ATTACHMENT "B"

PROPOSED SPECIFICATIONS

DESCRIPTION OF PROPOSED CHANGES NPF-10/15-222  
AND SAFETY ANALYSIS

This is a request to revise Technical Specification 3/4.9.6, "Refueling Machine."

# REQUIRED STORED BORIC ACID VOLUME AS A FUNCTION OF CONCENTRATION

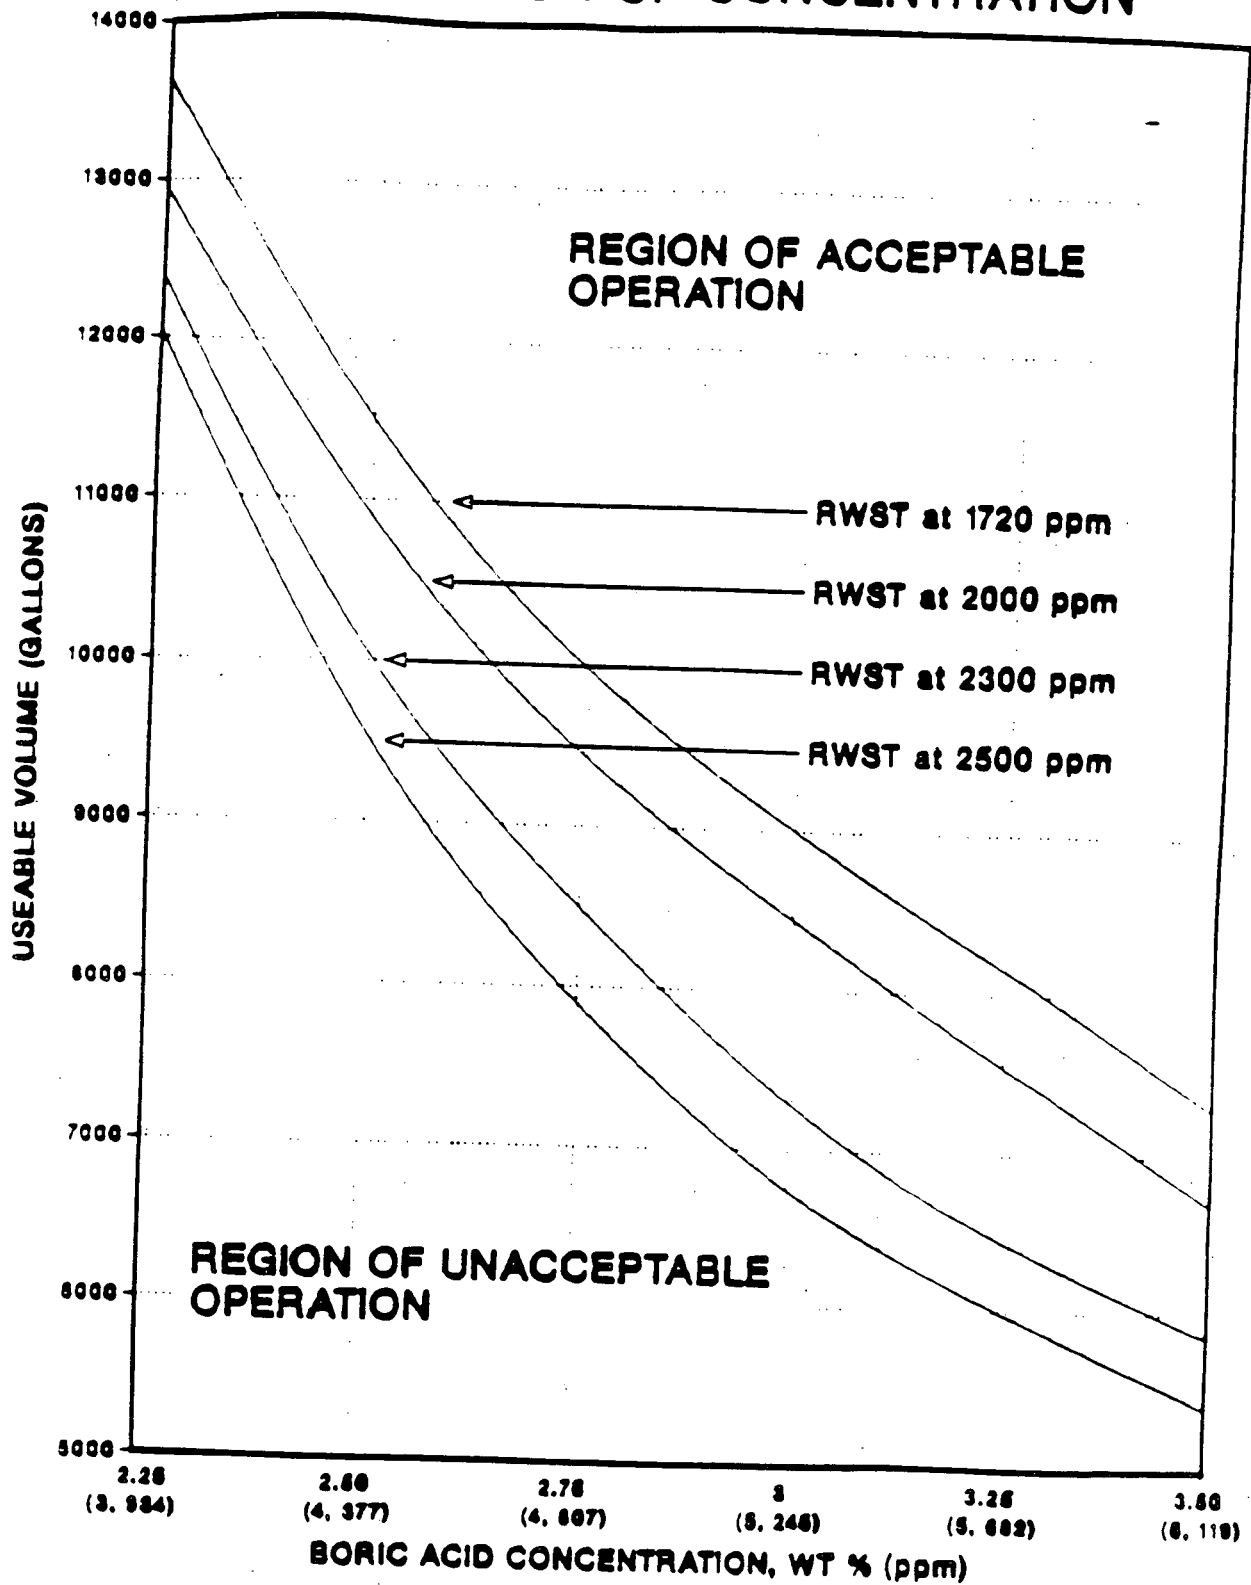
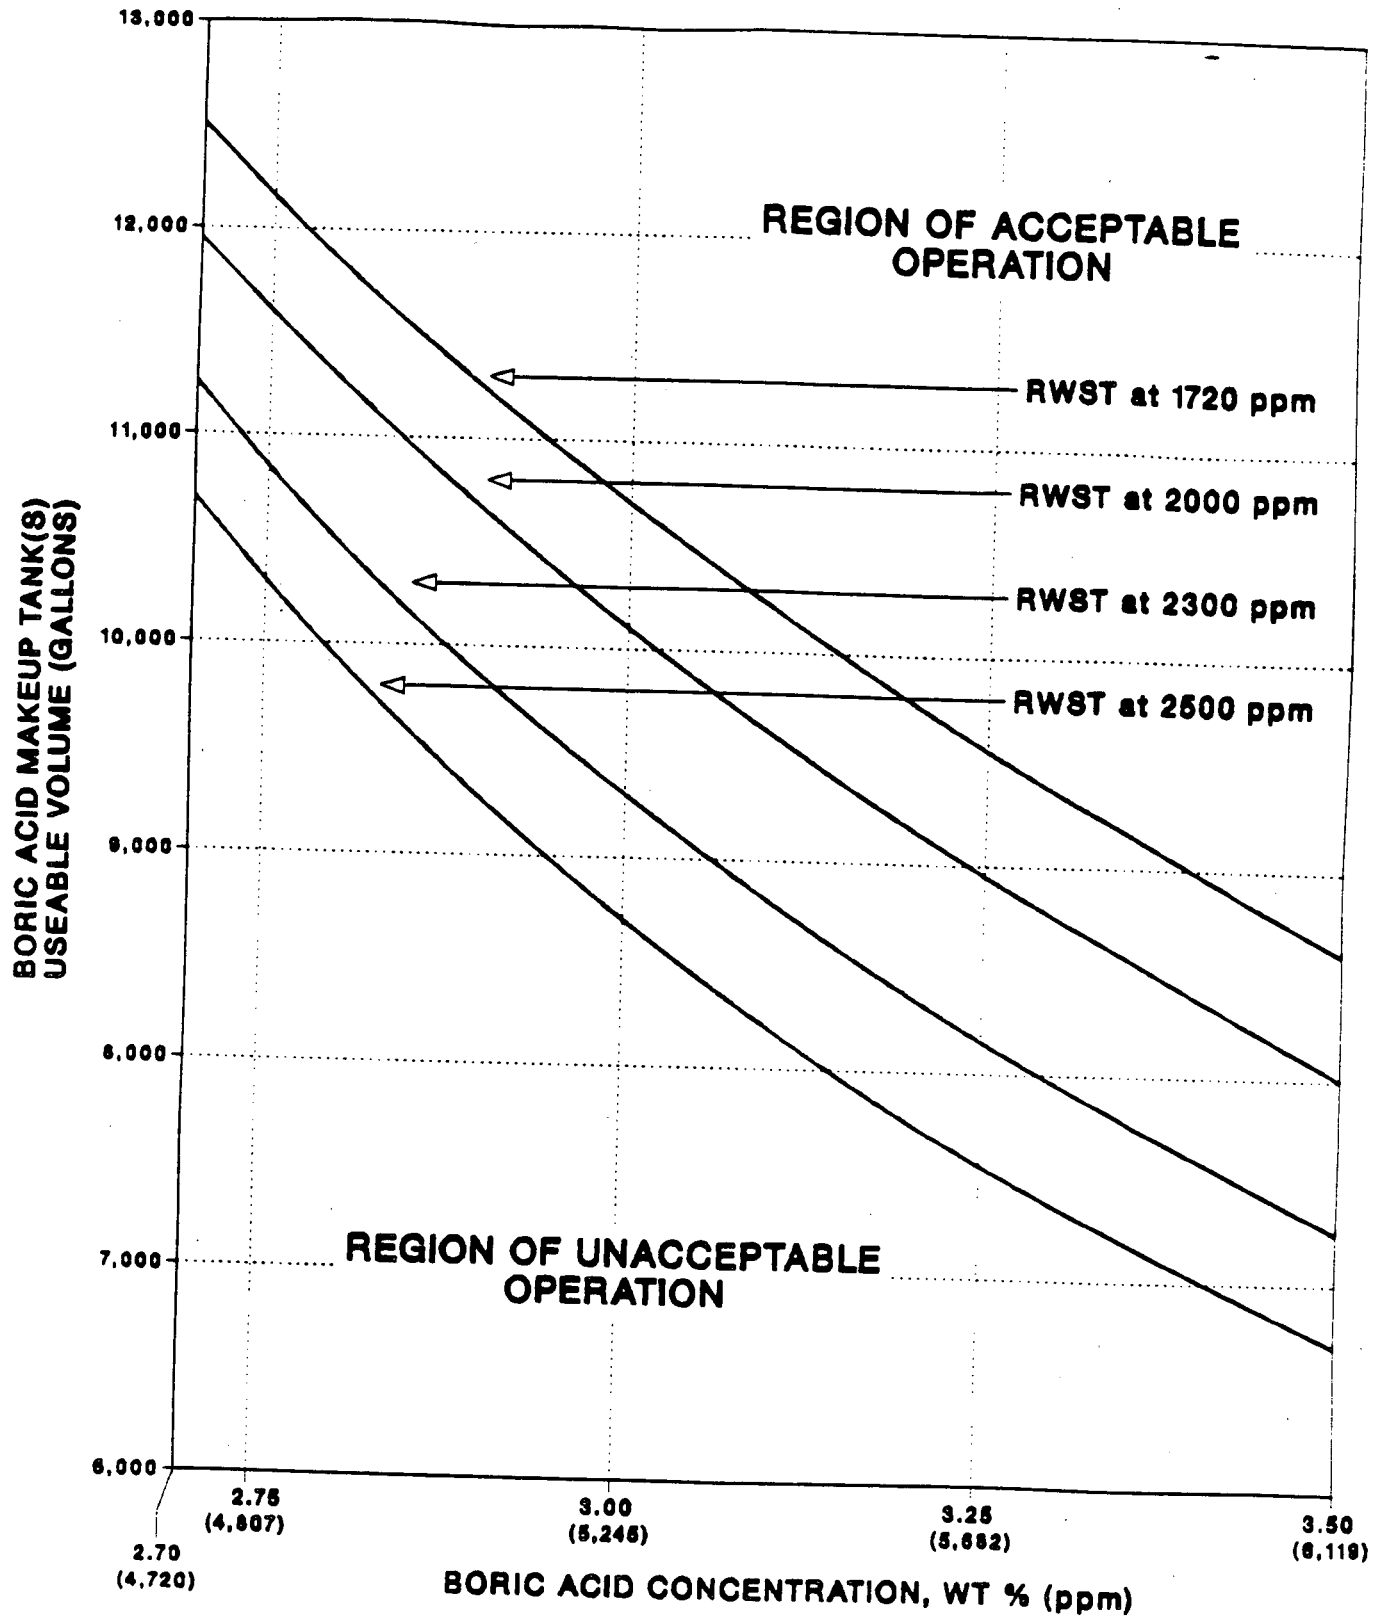
- a. One boric acid makeup tank with a minimum boron concentration of 1720 ppm and a minimum borated water volume of 5150 (7150, Cycle 2) gallons, or
- b. The refueling water storage tanks with:
  1. A minimum borated water volume of 5150 (7150, Cycle 2) gallons above the ECCS suction connection,
  2. A minimum boron concentration of 1720 ppm, and
  3. A solution temperature between 40°F and 100°F.

The boron capability required below 200°F is based upon providing a 3.0% delta k/k SHUTDOWN MARGIN after xenon decay and cooldown from 200°F to 140°F. This condition requires 5150 (7,150, Cycle 2) gallons of 1720 ppm borated water from either the refueling water tank or boric acid solution from the boric acid makeup tank.
